**SUBJECT: SUBMITTAL OF COMMENTS ON THE FOURTH YEAR OF IMPLEMENTATION OF
THE REACTOR OVERSIGHT PROCESS THING**

Comments on the 4th Year of the Reactor Oversight Process

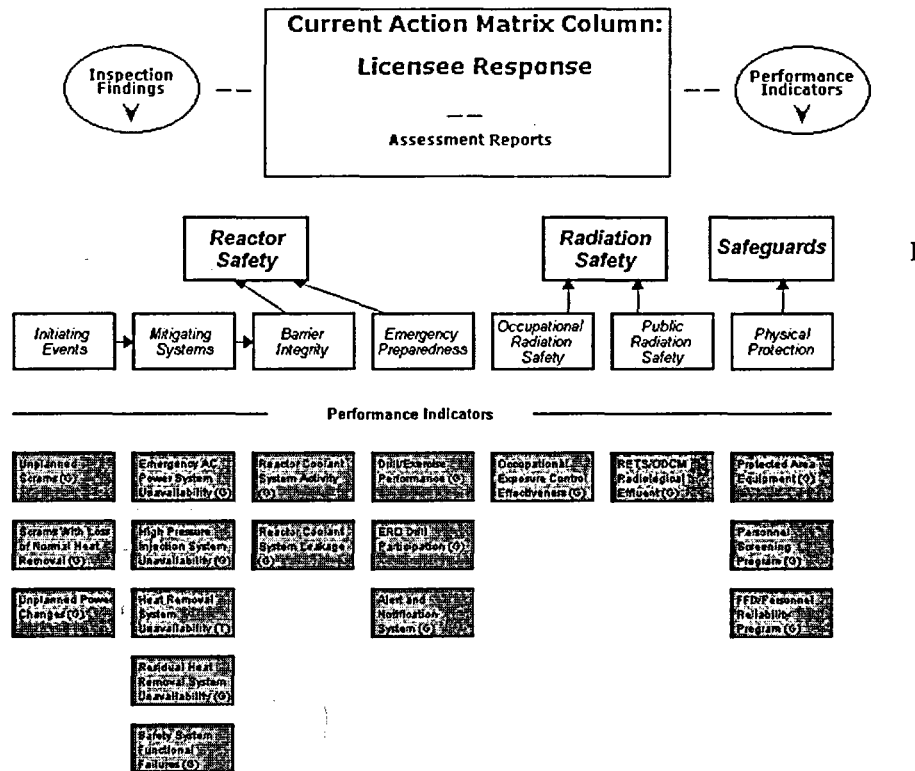
As an example of a problem the NRC should not fix, consider the Performance Indicator results for individual plants. Here's the webpage for Dresden:

have a high-resolution computer monitor set up for 1024 x 768 pixel display, yet all I see on the screen when I call up the PI results for any reactor is the top half of the information. In other words, I see everything but the PI results on the PI results screen. I don't understand why the NRC hides the dynamic information "below the fold" and keeps the static information in plain view.

Information about the reactor oversight process is posted on the NRC's website. Considerable material is available, but it is organized so poorly as to be extremely difficult to access. I frequently give up when looking for information after several unfruitful clicks. BUT UCS RECOMMENDS THAT THE NRC NOT REVISE THE WEBSITE. EVERY TIME THE NRC "IMPROVES" ITS WEBSITE, IT GETS HARDER TO USE.
